Access Compliance Report Public Rights-of-Way (Curb Ramps)

Main Street: JENET_CIR **Cross Street:** ERVIN_LN **Location:** NE

ADA ID: RPAT211005140919 **Ramp Type:**Type 1 - Perpendicular Diagonal Initial Pass/Fail: Fail **Overall Compliance:** No **Severity Score:** 5

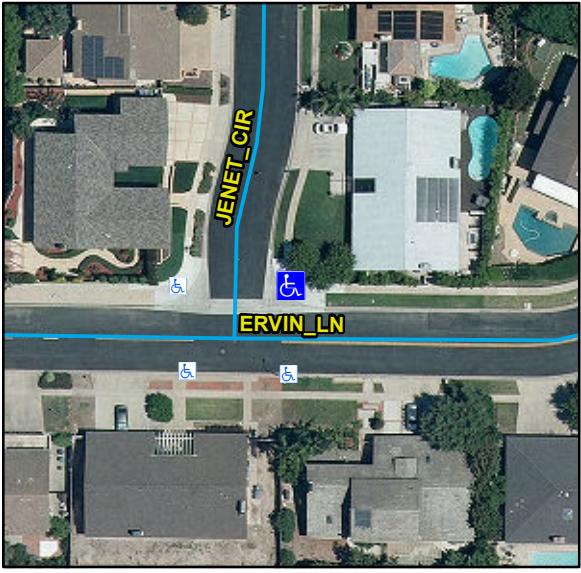
Compliance	Description	Data	Compliance	Description	Data
N/A	Ramp Length (in)	69	N/A	Flare Type LT	
No	Ramp Width (in)	47			N/A
Yes	Ramp Run Slope (%)	7.9	N/A	Flare Slope LT (%)	N/A
Yes	Ramp Cross Slope (%)	0.5	N/A	Flare Traversable LT	N/A
N/A	Landing Present	N/A	N/A	Flare Type RT	
N/A	Landing Length (in)	N/A			N/A
N/A	Landing Width (in)	N/A	N/A	Flare Slope RT (%)	N/A
N/A	Landing Run Slope (%)	N/A	N/A	Flare Traversable RT	N/A
N/A	Landing Cross Slope (%)	N/A	N/A	DWS Provided	N/A
N/A	Landing Movement Obstructed?	N/A	N/A	DWS Contrast	N/A
	Landing Movement Type	N/A	N/A	DWS Length (in)	N/A
N/A	Landing Shared	N/A	N/A	DWS Full Width	N/A
N/A	Clear Space	Yes	N/A	DWS Offset Left (in)	N/A
N/A	Clear Space To Crosswalk (in)	N/A	N/A	DWS Offset Right (in)	N/A
N/A	Marked Crosswalk 1	No	N/A	Marked Crosswalk 2	No
	Crossing 1 Direction	W		Crossing 2 Direction	S
	Marked Crosswalk 1 Width (in)	N/A		Marked Crosswalk 2 Width (in)	N/A

Possible Solutions:
Remove & Replace Curb Ramp With Two New Directional Ramps or Equivalent.
